Response to Draft AEMO 2022 Integrated System Plan

10 February 2022

Submitted by
Independent engineers and scientists

Figure 1 CSIRO GenCost 2020-21 Report with markups using its previous report

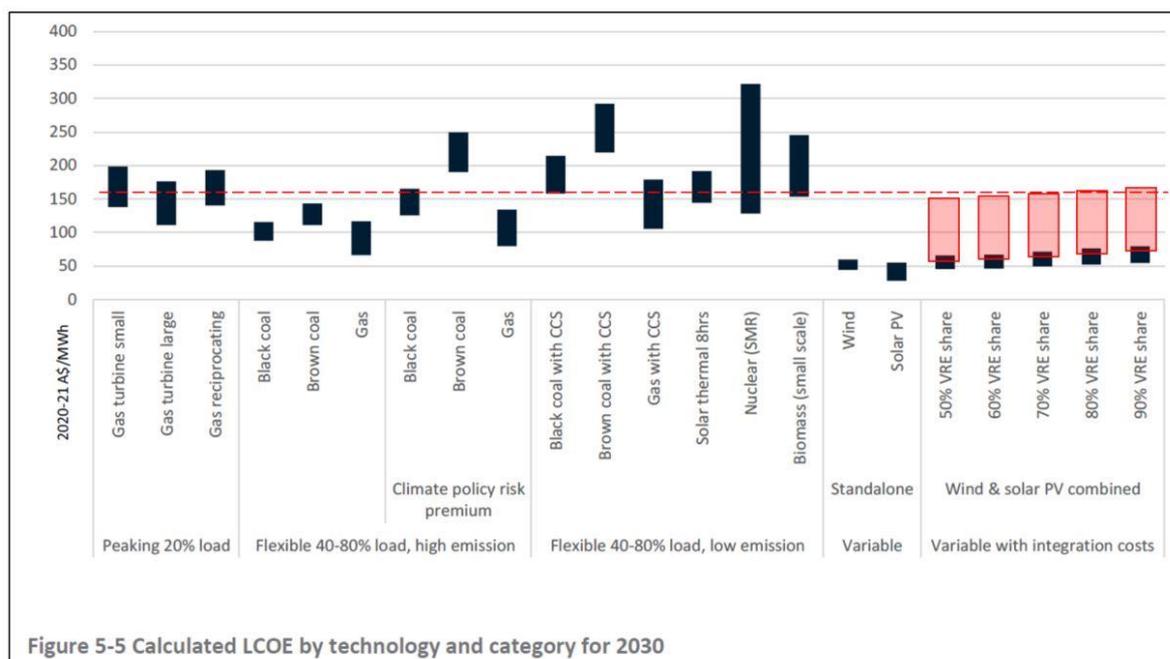
- (e) In the previous CSIRO report, integrated VRE costs included energy storage at \$19 to \$106/MWh (2 to 6 hours of storage) but did not include transmission lines and synchronous condensers (nor probably land, interconnectors, standby baseload fossil fuel plants, energy management systems and disposal/recycling since these are not mentioned).

- (f) In its current report, CSIRO states that costs to support renewables have been lowered to \$6 to \$19/MWh based on a less conservative approach, which assumes some RE will always be available in the NEM (p60). This appears to reflect the system design philosophy of the ISP to provide extensive interconnectors throughout the NEM to move energy from where it is available to where it is needed. The report did not state whether these new support costs, about 80% lower, include the costs of the land, interconnectors, synchronous condensers, energy management systems and disposal/recycling. Nor did it state whether the limited lifetime of batteries was taken into account.

- (g) The reason for this substantial lowering of VRE support costs is dubious, given the assessments in Sections 4.4 and 4.5 below. If these costs had been kept at the same level, Figure 5-4 of the CSIRO report, which provides a comparison of LCOE for various energy sources, would look like Figure 1 below which is marked up to show that CSIRO’s previous integrated wind and solar LCOEs are not the least expensive approach to electricity generation but are on a par with gas and the lower range of nuclear. Given the lack of detail and rigour in the CSIRO report, it is necessary for a rigorous and independent review be done.
